Our Ref: 34918-002-01
Your Ref: OUT23/782

**Response to Further Information Request
Development Application for Material Change of Use (Low Impact Industry)
136 Crossland Road, Gordonvale – Lot 2 on RP747646**

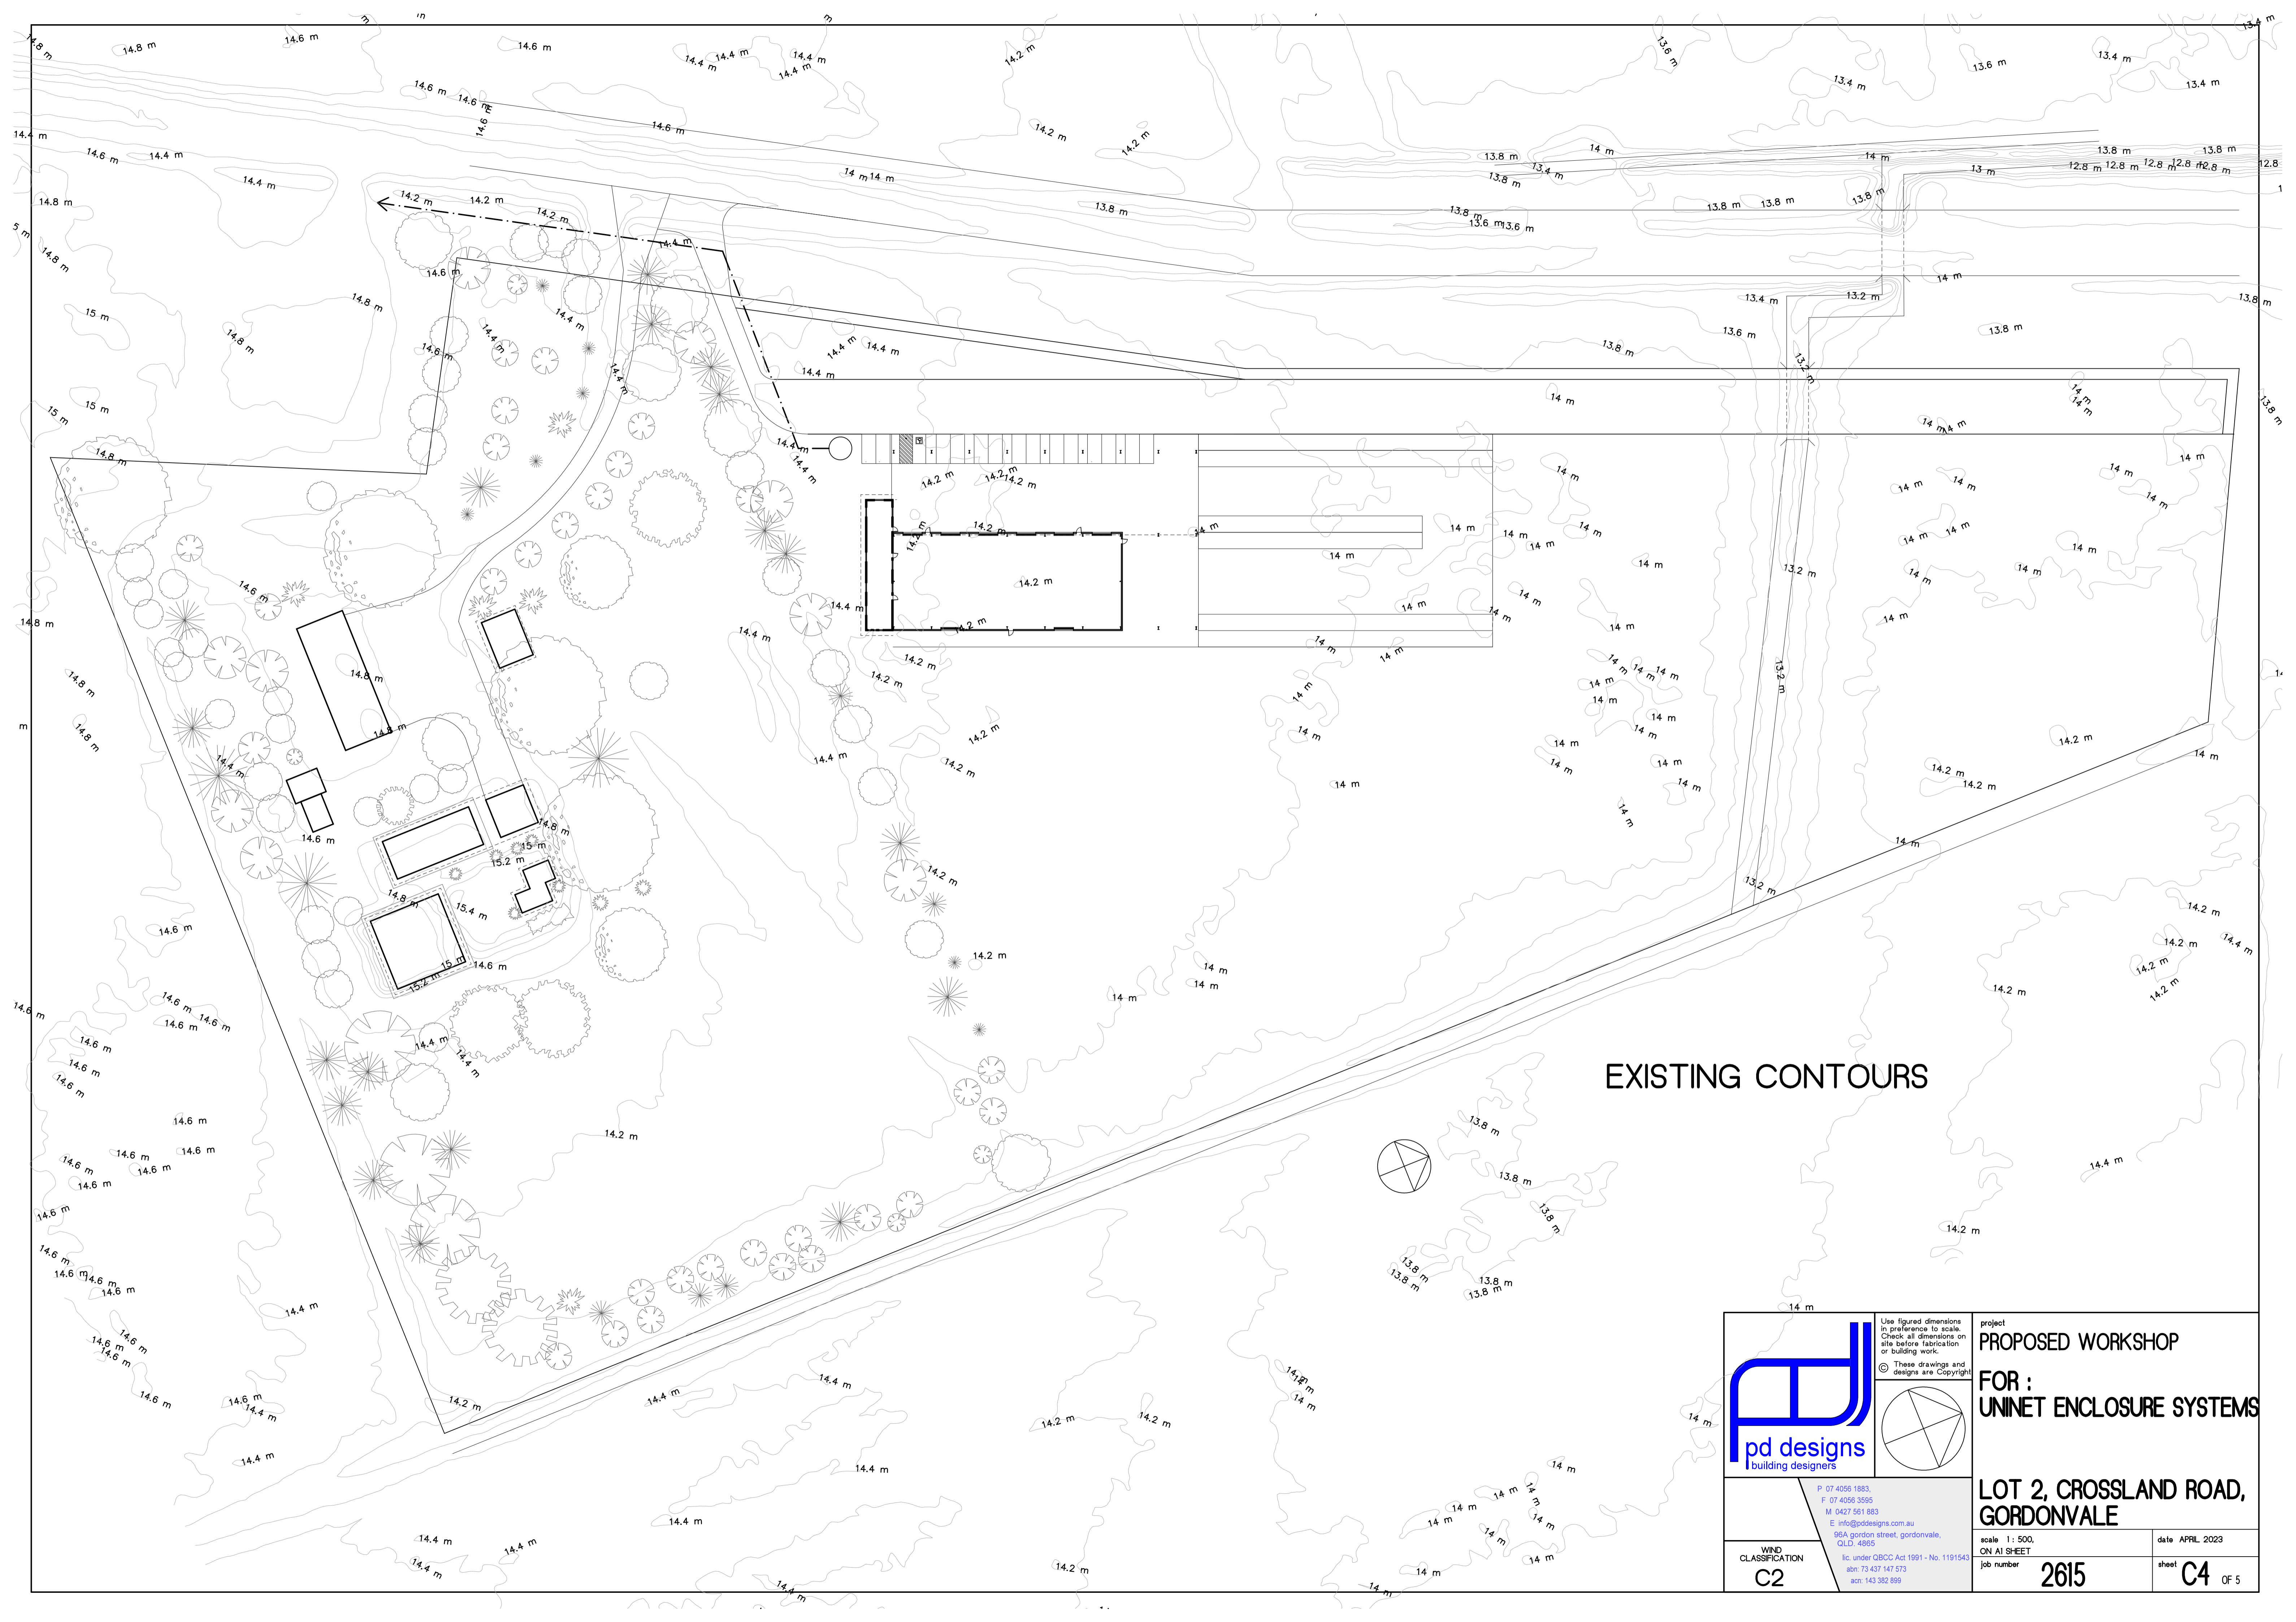
2. *The response to the Coordinator-General's information request on 16 February 2023, included plans that indicated a drainage flow path through the subject site. Drawing No.2615 C4 prepared by PD Designed dated February 2023 indicates a 20-metre-wide drain profile on the site.*

- *That there are no impacts to the drainage flow path through the site, and that the flow paths on the site will continue to operate without directing flows, due to the hardstand location; and*
- *There is a no worsening impact on upstream and downstream properties for the entire development.*
- *Nominate the proposed culvert sizing located within the hardstand area and towards the north along the identified drainage path and demonstrate that the culvert capacity matches the current drain capacity.*
- *Provide a local drainage study to support any changes in capacity, if required.*

3. *The response to the Coordinator-General's information request on 16 February 2023, included Drawing No.2615 C4 prepared by PD Designs, dated February 2023 which indicates a 20 metre wide access crossover which is not considered in accordance with the FNQROC Development Manual. In addition, the proposed crossover illustrated in plans is located within one metre to a power pole, which is not considered to be designed in accordance with the FNQROC Development Manual.*

- The proposed location of the access crossover, designed to commercial/industrial standard, in accordance with the FNQROC Development Manual Standard Drawings S1015 and S1110; and
- The access crossover is to be setback by no less than one (1) metre from the identified power pole in accordance with the FNQROC Development Manual.

Reference is made to the attached amended drawings C1-C5 included within *Attachment A*. The level of the northern half of the hardstand has been reduced to RL14.0m which is the same as the adjacent roadway. Thus the hardstand would not have an effect any greater than the existing roadway. This occasional inundation of the hardstand would not affect operations. As detailed in our previous response, the balance of the proposed development is almost entirely above flood level.

Reference is made to the attached amended drawings C1-C5. The proposed culvert size within the hardstand is twice that of the existing road culvert which, together with the hardstand level of 14.0m, more than matches the current drain capacity.

The construction of the existing road adjoining the site is of a rural nature with a table drain and crossover culverts rather than a curb and channel construction. As set out in the FNQROC Standard Drawings the details of the non-standard design would be provided for approval at the time of construction. It would be expected that the development can be appropriately conditioned that construction plans for the crossover must be approved prior to works being undertaken onsite.

The position of the existing power pole will allow for the 1 metre setback to be achieved. The development can be appropriately conditioned ensuring the 1.0m is achieved with the final design of the new crossover.

MEDIUM RIGID SWEEP PATH
1:100

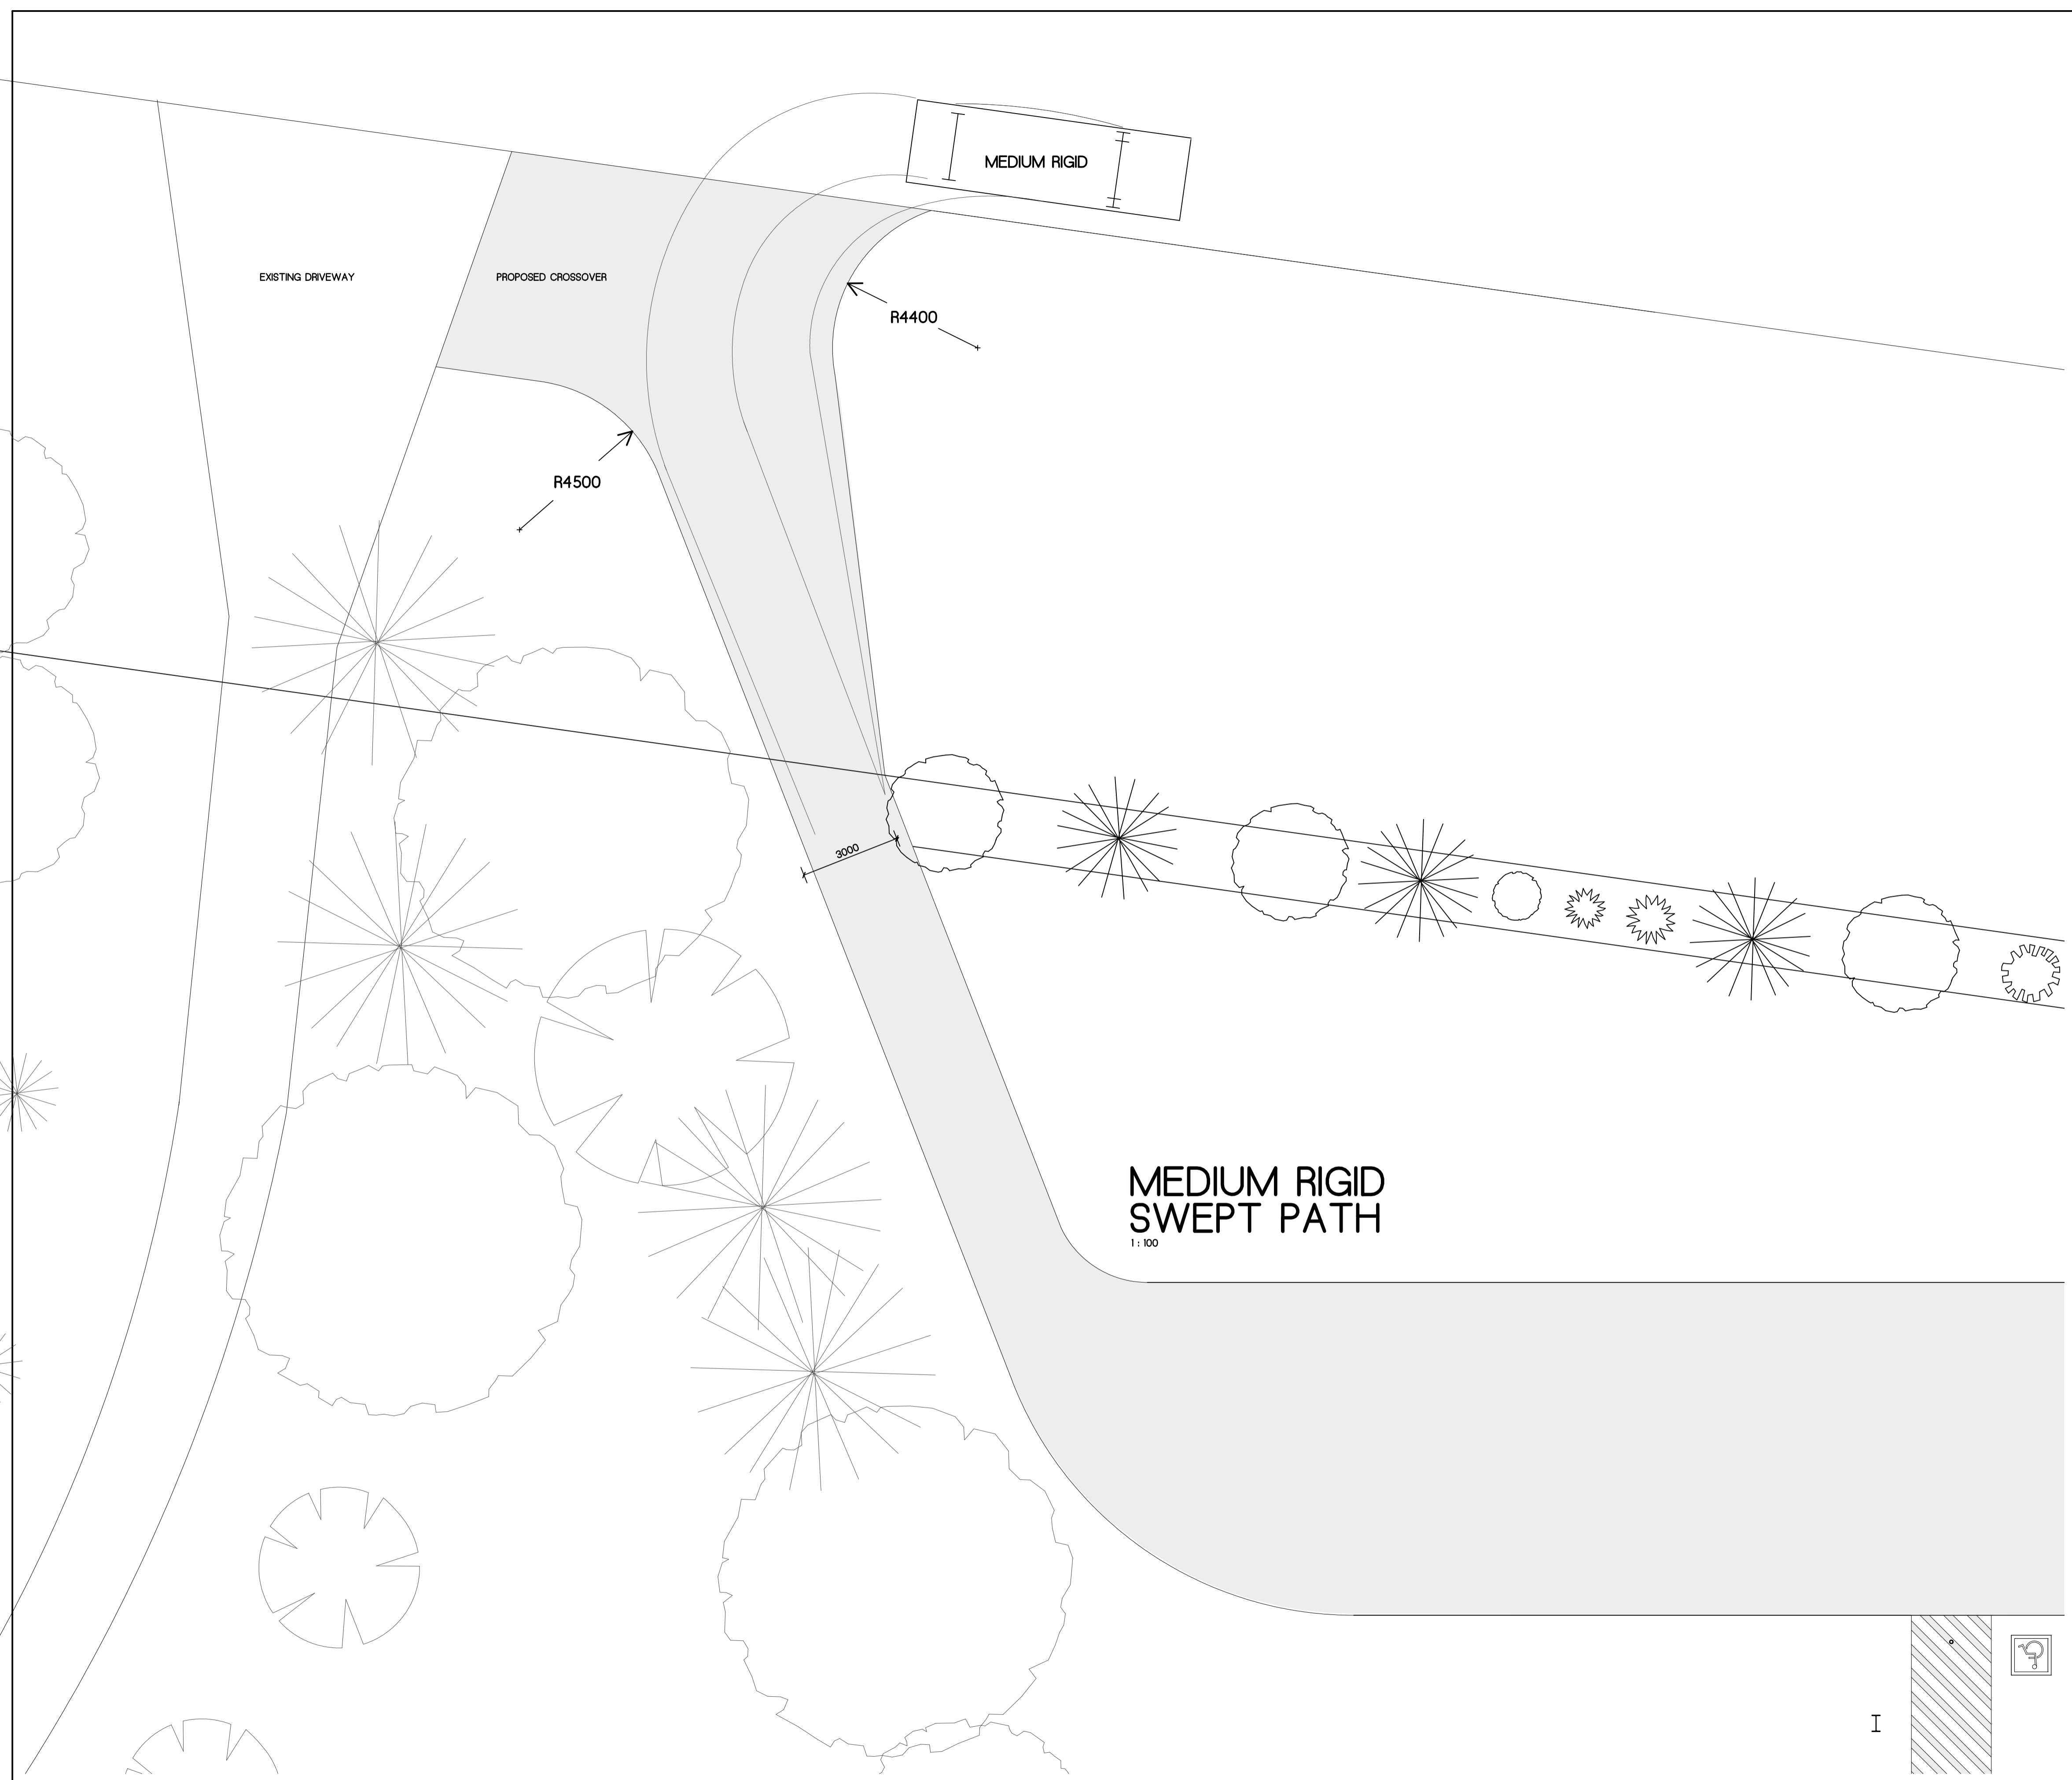
The proponent is requested to confirm the largest expected vehicle to access the site and number of vehicle movements per day expected by this vehicle.

The largest expected vehicle to access the site would be a Medium Rigid Truck at a frequency of 1 movement per week.
